**Bollettino di servizio  
Service Bulletin  
S-001 MANDATORY  
Whirlwind propeller**

A B22R engine installed in South Africa coupled to a Whirlwind propeller experienced a loss of lubricant from reduction box gear cover when cap screw became loose. This propeller have never been tested nor approved by MW Fly for use on MW Fly engines, and there is no information about the static and dynamic balance of the propeller. A full investigation on the probable cause is in progress. Additional Service Bulletin (s) will follow.

Check the tightness of gear cover cap screws, torque setting M8 20/22 Nm

**Figure 1**

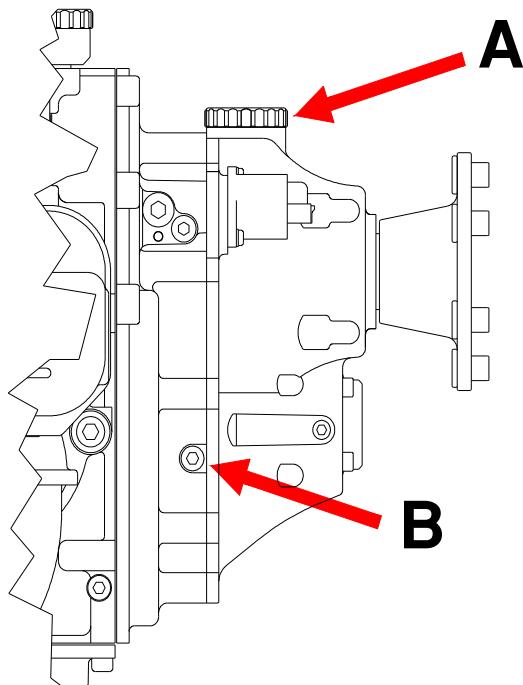
- a. be sure that the engine is horizontal position
- b. unscrew the gear oil filler cap (A) as shown in figure1

- c. visually check the oil level in the gear box
- d. loosen the oil level bolt (B) on check the oil as show in figure 1
- e. unscrew the bolt (B) until you see a leak of oil that should increase if you keep unscrew the cup (B)
- f. if there is no leak or even when the bolt (B) is completely unscrewed, replace the cup in the hole and refill the gearbox as explained in the Manual A (installation manual) chapter A.15.4. writing down the quantity of oil necessary to fill the gear box to the correct level. Proceed with the all following steps up to 3.5 included.
- g. if you notice a leak of oil tighten the cap (A) and (B) and proceed to the following step 3.3

**Figure 2**

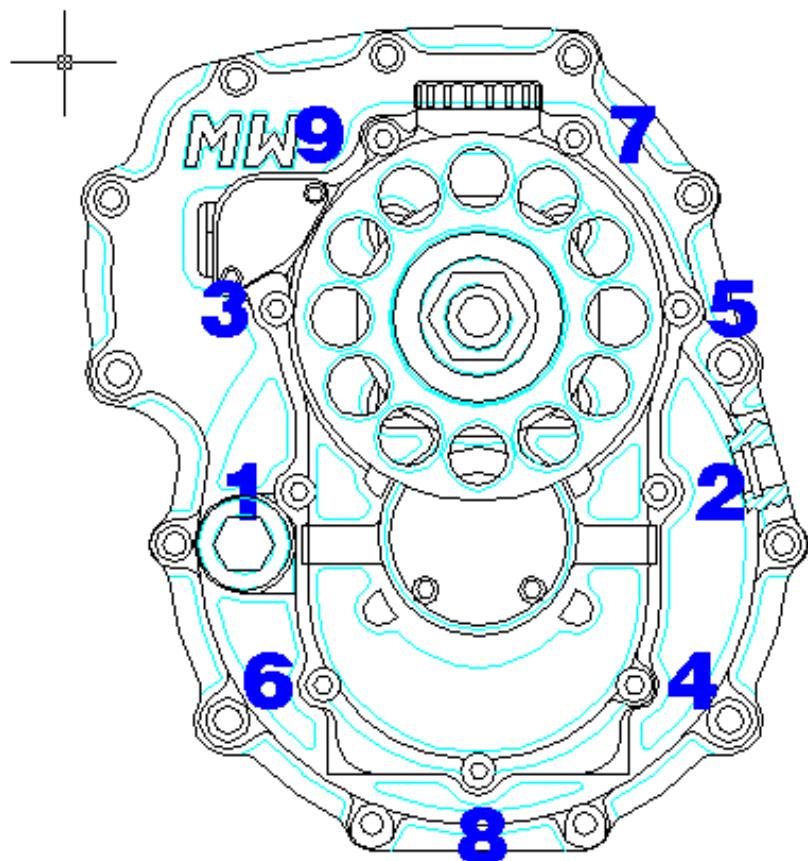
**WARNING: do NOT for any reason unscrew the bolt after checking the final torque.**

**WARNING: do not use any washer under the bolt**

- a. set the torque wrench at 22Nm
- b. try to tighten each M8 bolt, shown in figure 2, and verify that the torque wrench indicates the proper torque value without the bolt rotating.

- c. if the torque wrench does not release immediately indicating that the torque value is correct, but instead the bolt rotates substantially before reaching the correct torque value, write down of the rotation done for each bolt and proceed with the following steps up to 3.5 included
- d. if all the bolt are correctly tight proceed to the following step 3.4
